TO: Mercedes-Benz Dealer Principals, General Managers, Sales Managers, Service Managers, Parts Managers	FROM: Gregory Gunther, Department Manager, Vehicle Compliance and Analysis, Engineering Services
RE: <b>Recall Campaign Launch Notification</b> <b>2018100002</b> <b>Rear Seatbelt C-Pillar Paneling</b> <b>MY16-18 X253 (GLC-Class)</b>	DATE: October 24, 2018

Campaign No. 2018100002, October 2018

SUBJECT: **Model X253 Model Year 2016-2018**  
**Rework trim on right and left C-pillars**

**Figure 1**

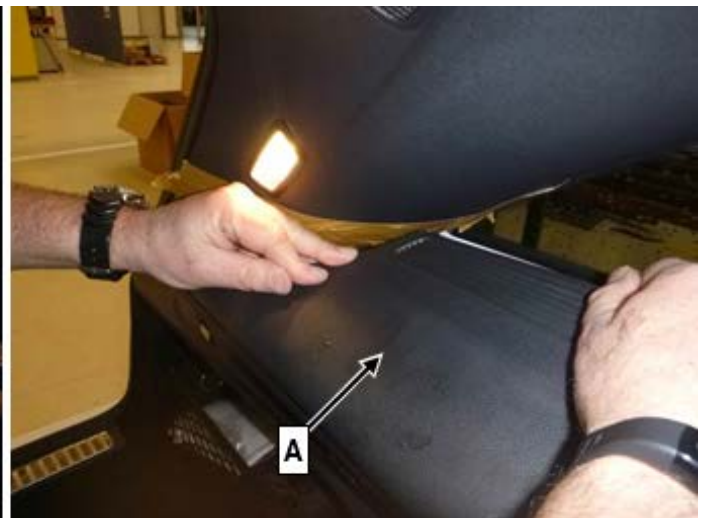
1. Release and remove luggage compartment cover.
2. Mask off D-pillar trims in trunk on both sides (**Figure 1**).

**Figure 2**

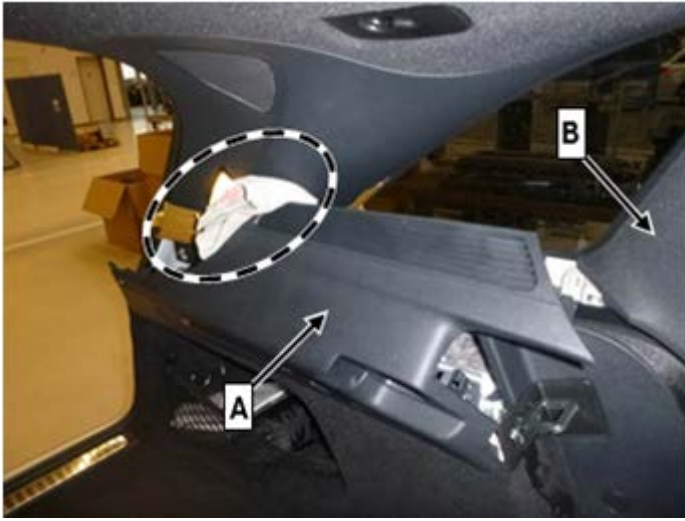
3. Release trunk linings (**A, figure 2**) at rear left and right on D-pillar using plastic wedge and manually unclip in upper area (**figure 3**).

**i** Press edge guard (**figure 2**) only slightly to side.

**Figure 5**

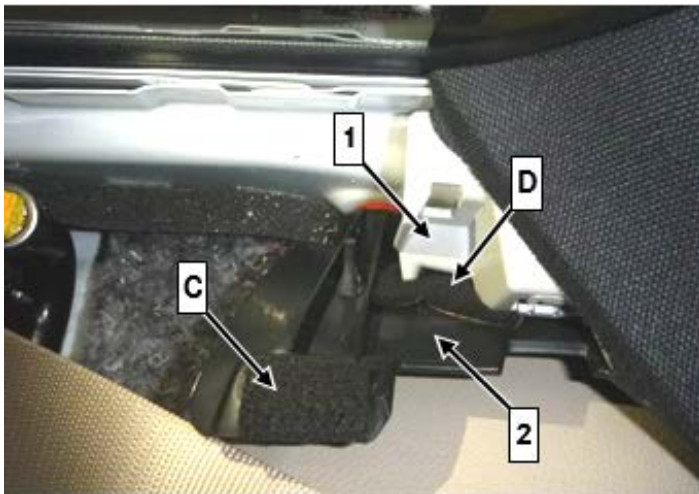
5. Glue in felt **(C, figure 5)**.

**i** Use **3 mm** felt!

6. Trap felt **(D)** between upper part **(1)** and lower part **(2)** of C-pillar **(figure 5)**.
